ADDENDUM NUMBER 1:
CITY OF PORTSMOUTH, NEW HAMPSHIRE
RYE LINE WASTEWATER PUMPING STATION IMPROVEMENTS
CONTRACT DOCUMENTS AND TECHNICAL SPECIFICATIONS

Issued: August 21, 2008
For Bids Due: August 28, 2008

E-1a

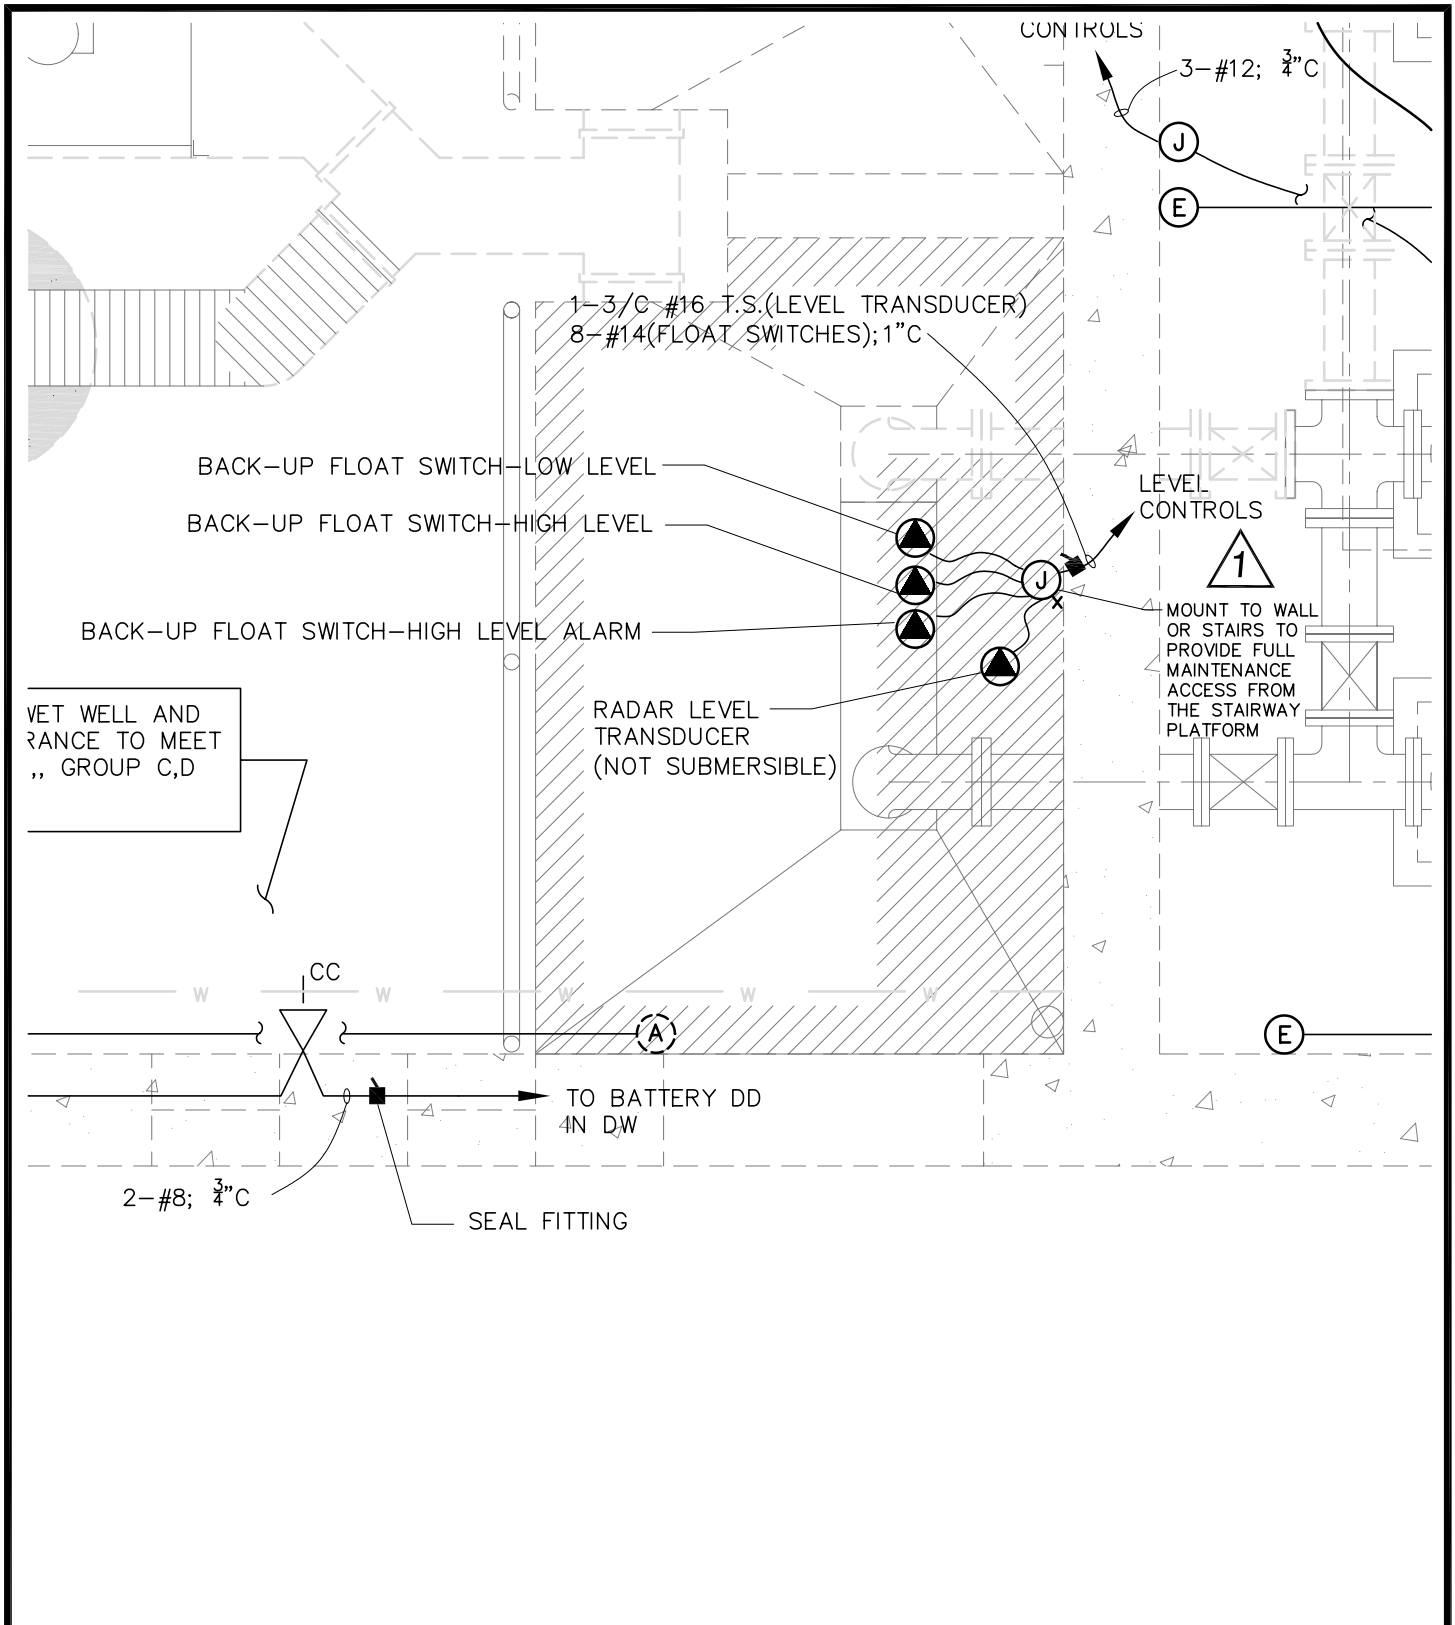
Sheet E-1 is modified as follows: There was an addition added to the Legend. Please see the attached 8½ x 11 sheet showing this change, labeled E-1a.
